Application for Works Approval

Works Approval Number W6922/2024/1

Applicant Golden Grove Operations Pty Ltd

Date of report 24/07/2024 (FINAL)

Figure 1: Schematic of dewatering flow (source – Golden Grove Operations Pty Ltd. 2024, Response document to 21-day package)

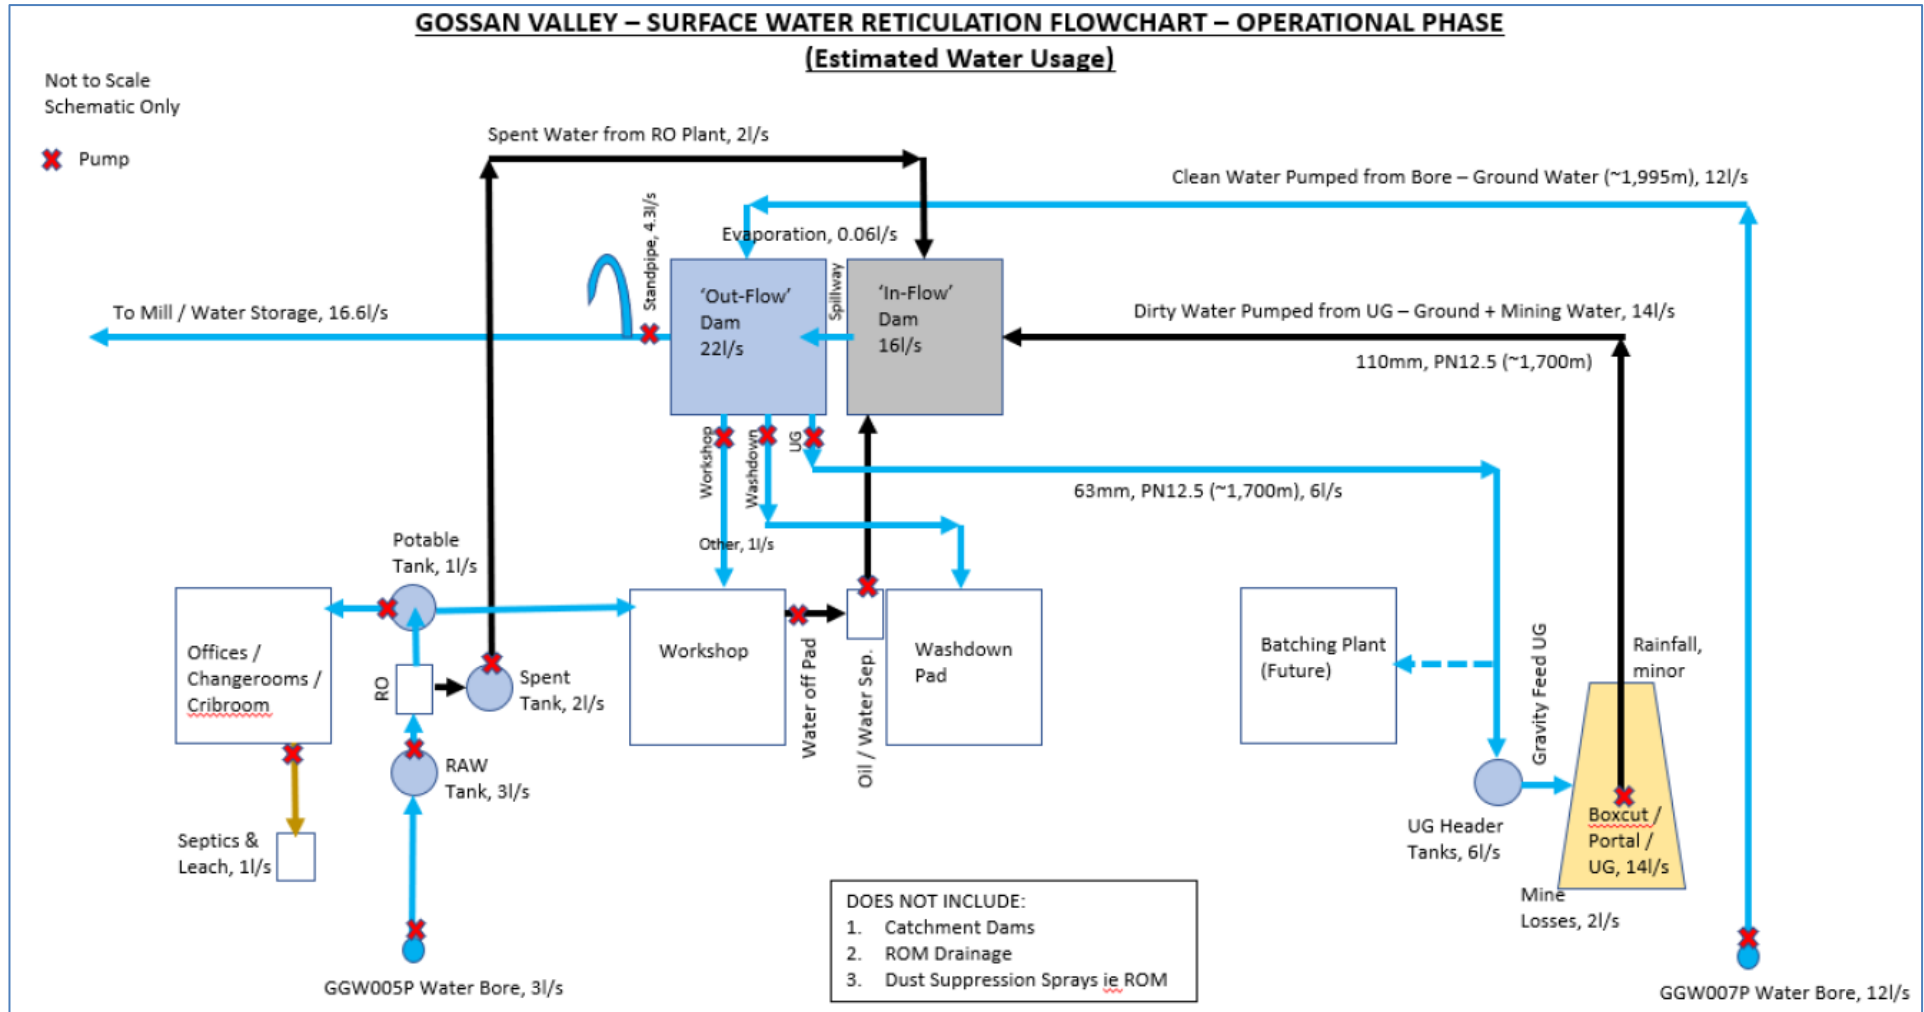
<p>2.2.3 Dewatering dams – inflow and outflow</p>	<p>3. What is the design performance of the oily water separator for total recoverable hydrocarbons and other potential contaminants of concern?</p>	<p>This is out for final design but an indicative unit is a Cleanawater TS5000 SS oil water separator. From their webpage/brochure, the expected performance is:</p> <ul style="list-style-type: none"> i. Typical TPH Influent < 5000-6000ppm ii. Typical TPH Discharge (treated) < 30ppm 	<p>Information added to section 2.2.3 of the Decision Report.</p> <p>'The Gossan Valley – Surface water flow chart – Operational phase (Estimated water usage)' has replaced the diagram of the dewatering dams as Figure 1.</p>
	<p>4. How much concentrated brine is expected to be discharged into the inflow dam per discharge event and per annual period? What dilution ratio expected? How saline is the outflow water expected to be? It is noted that water may be used for dust suppression purposes within the GVP, this information is required to determine the extent of potential environmental impacts from reuse options and to facilitate the risk assessment process.</p>	<p>There is currently a confidential tender process underway for the supply and installation of the office/changeroom complex. Included in this scope of works is to supply and install and appropriated sized RO plant through a reputable supplier.</p> <p>On initial scoping, and in the included Table 1, it is expected that the brine ratio will be 2:1 (i.e. for every 3 litres of water, 2 litres is brine and 1 litre is Potable use water).</p> <p>Using this ratio, approximately 3.15ML of brine will be generated annually. This represents ~ 0.08% of total water per annum and thus salinity will only be marginally affected.</p> <p>Until the specific unit is designed and chosen, site does not have any other information to go off at present.</p>

<p>5. Applicant to provide a breakdown of expected volumes (estimates) to be used within the GVP for dust suppression above ground and underground, underground for other uses, within the washdown pad, at the workshop etc. (estimates only).</p>	<p>See the included Table 1 estimated volumes per annum. The table outline 3 phases.</p> <ul style="list-style-type: none"> i. Phase 1 (Prod bore only) ii. Phase 2 (Construction) iii. Phase 3 (Operational)
